**RE: Arby's Restaurant
6110 San Mateo NE
Grading and Drainage Plans
Engineer's Stamp Date: 10/16/25
Hydrology File: E18D065
Case # HYDR-2025-00399**

Based upon the information provided in your submittal received 11/04/2025, the Grading & Drainage Plans **are not** approved for Building Permit and Grading Permit. The following comments need to be addressed for approval of the above referenced project:

Sheet Title:
GRADING AND DRAINAGE PLAN

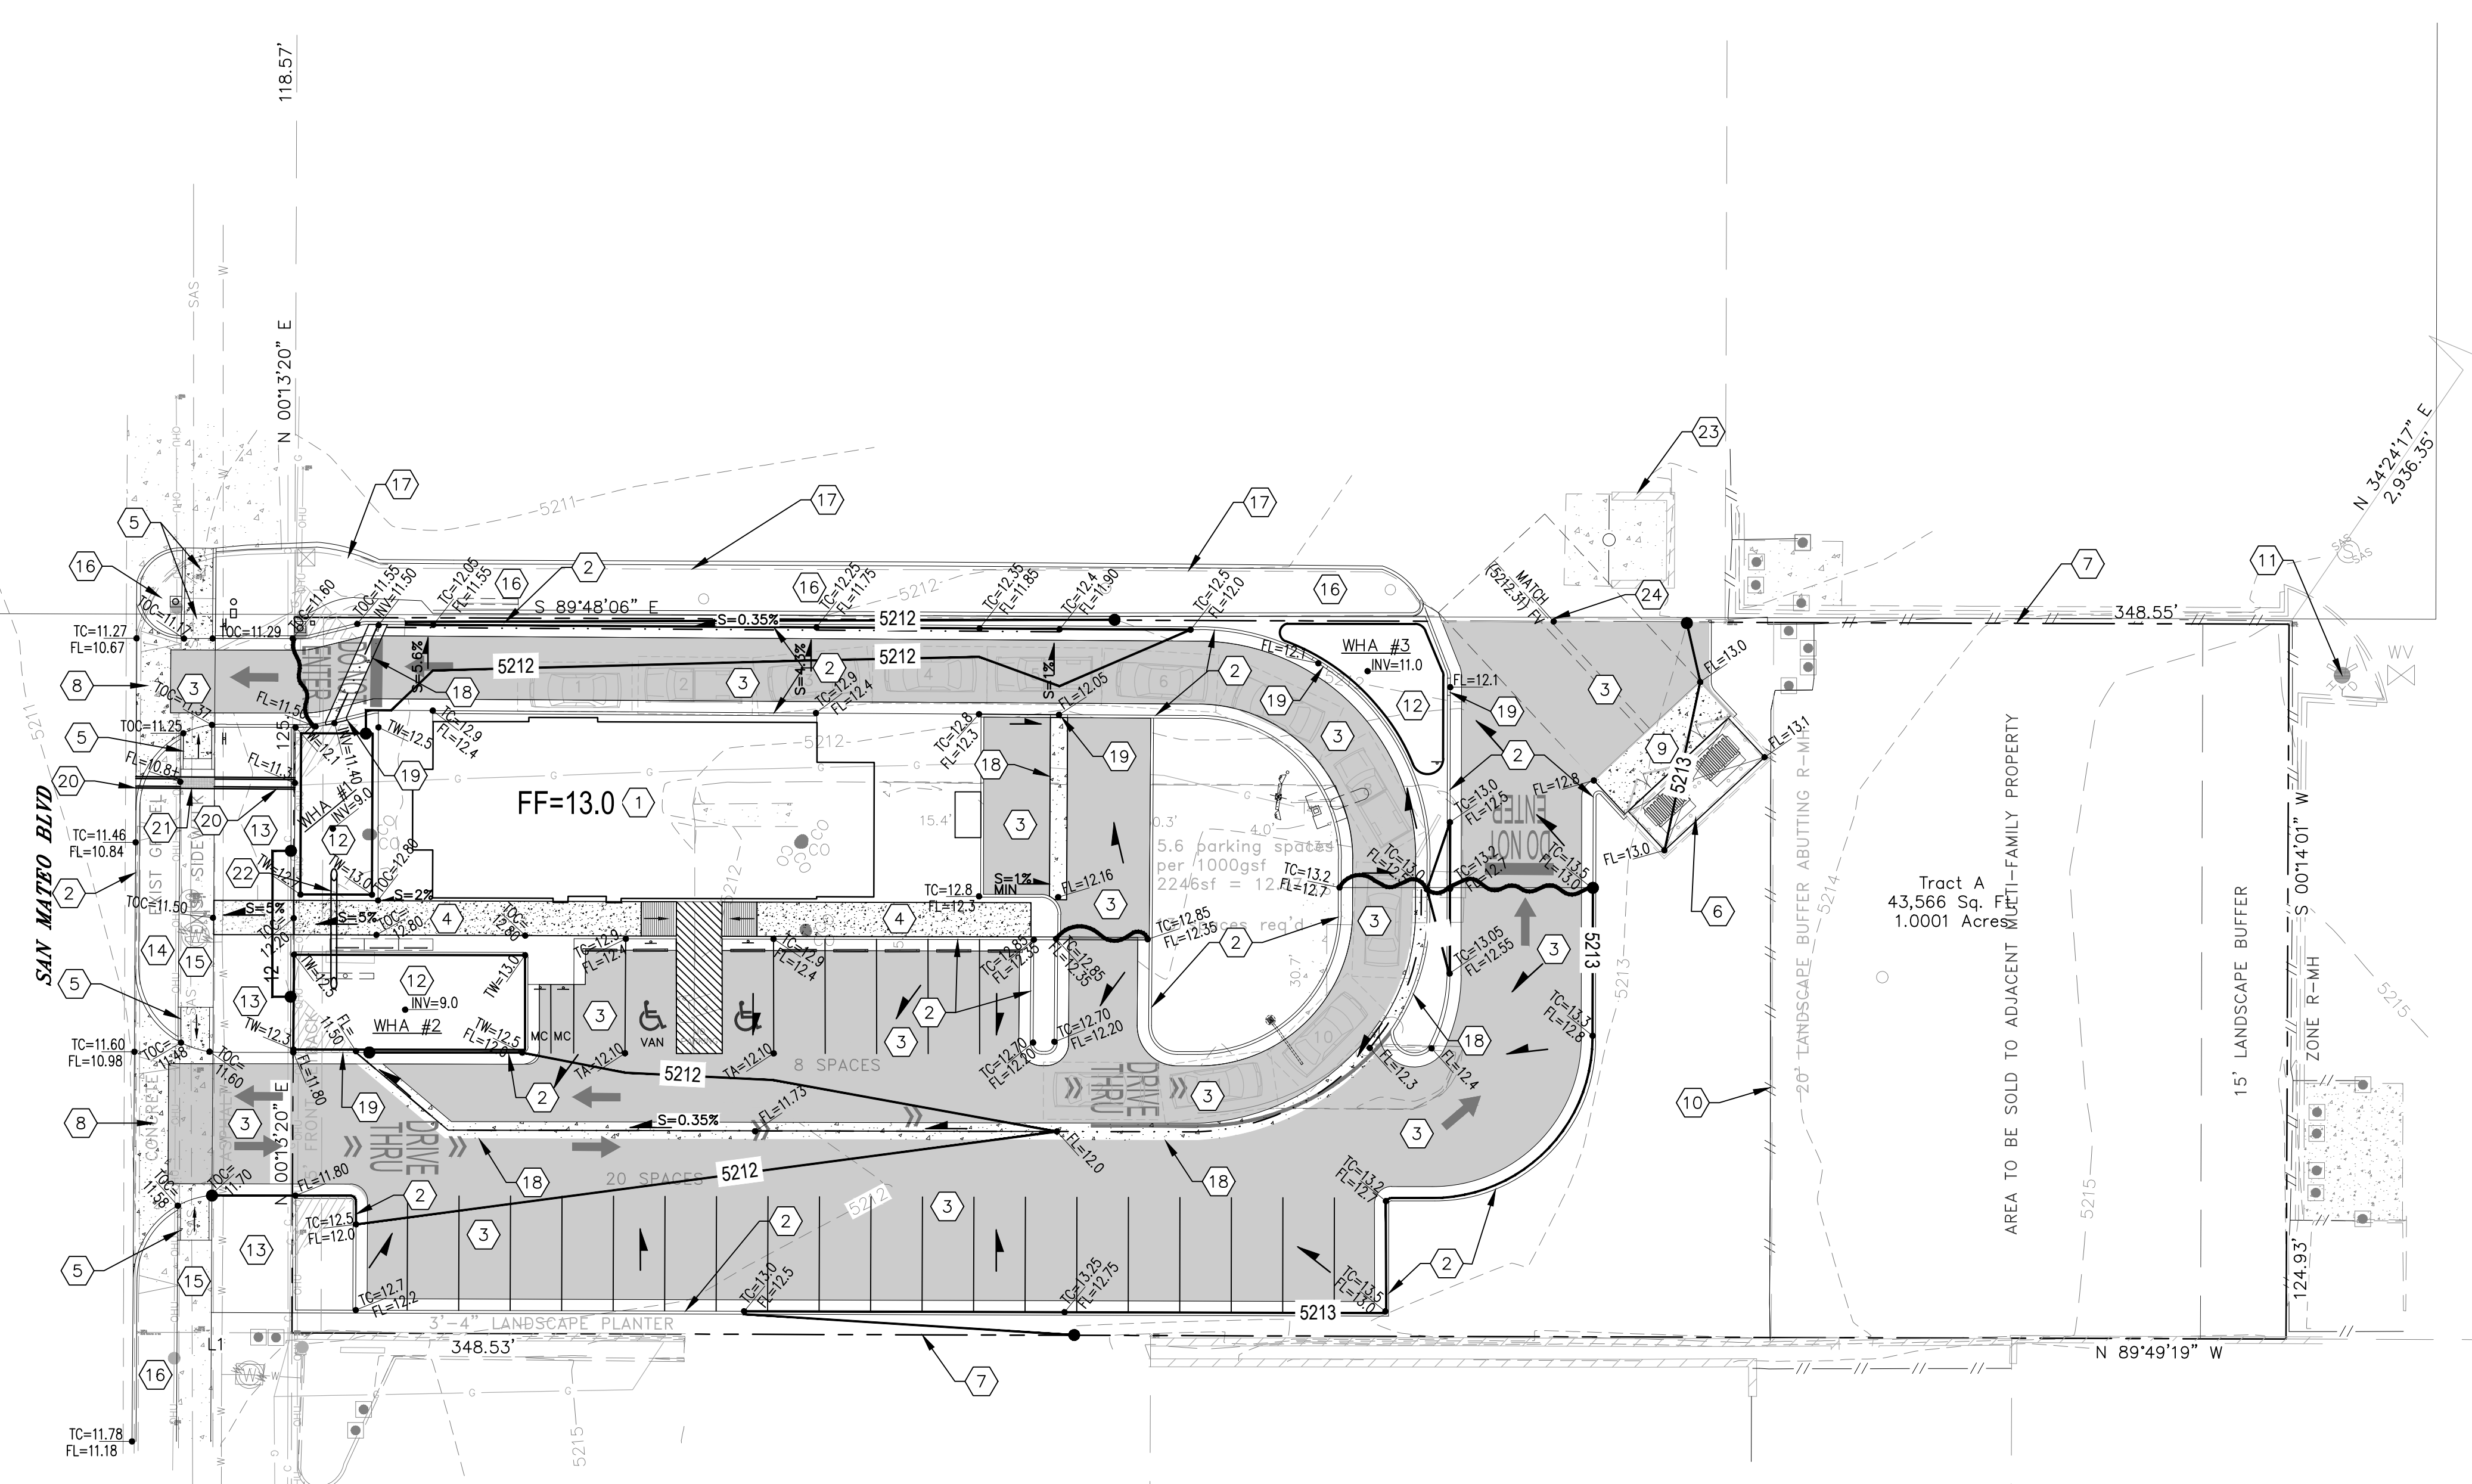
1. An SO-19 Permit will be required and should be included on the request. Please include the [standard SO-19](#) notes on the grading plan.
2. Please provide the Benchmark information (location, description and elevation) for the survey contour information provided.
3. For trash enclosures serving food service developments, trash enclosures must demonstrate control of liquids from dumpster areas per DPM by containing runoff from the dumpster area, preventing outside drainage from entering the dumpster area, and discharging to the sanitary sewer. Please show an inlet in the middle and label. "Inlet to be connected to the sanitary sewer. See Utility Plan."
